Amendments to the Drawings:

09/993,531
Amendment of 05/12/06
Annotated Sheet

Fig. 7

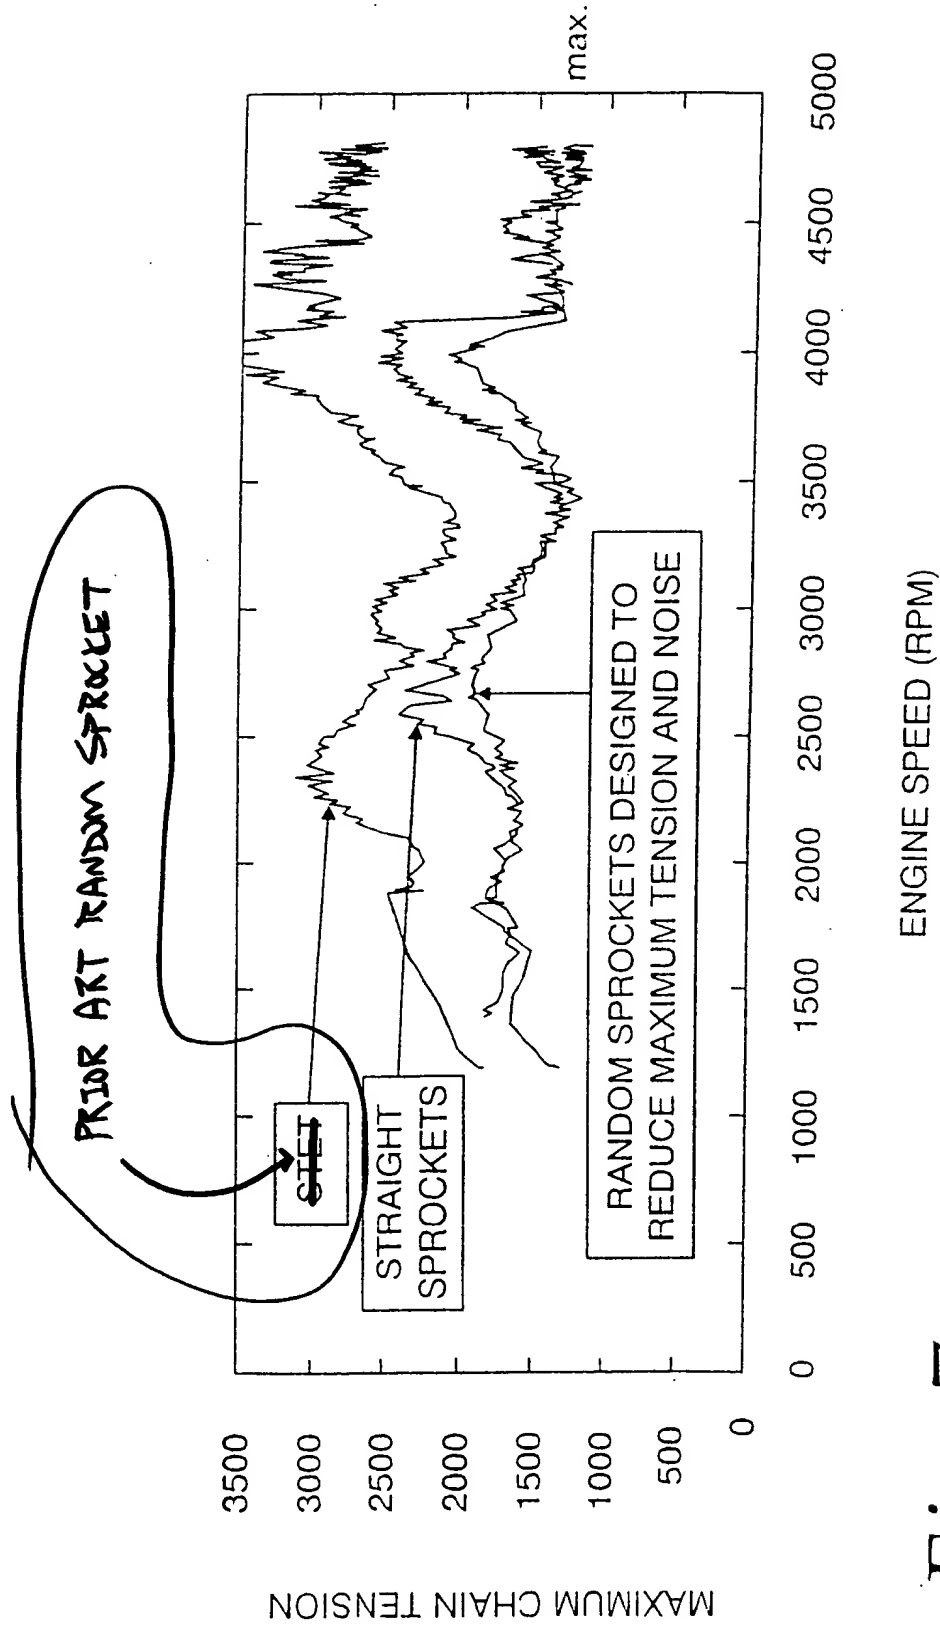
The attached sheets of formal drawings, which include Figs. 1-8, replace the original informal sheets including Figs. 1-8. The attached sheets of formal drawings also include changes to Figs. 7 and 8. In Fig. 7, "STET" has been changed to "PRIOR ART RANDOM SPROCKET". In Fig. 8, the innermost "PA2" has been changed to "PA1".

This amendment also corrects a pair of typographical errors in Figs. 7 and 8 of the drawings. In Fig. 7, "STET" has been changed to "PRIOR ART RANDOM SPROCKET". In Fig. 8, the innermost "PA2" has been changed to "PA1".
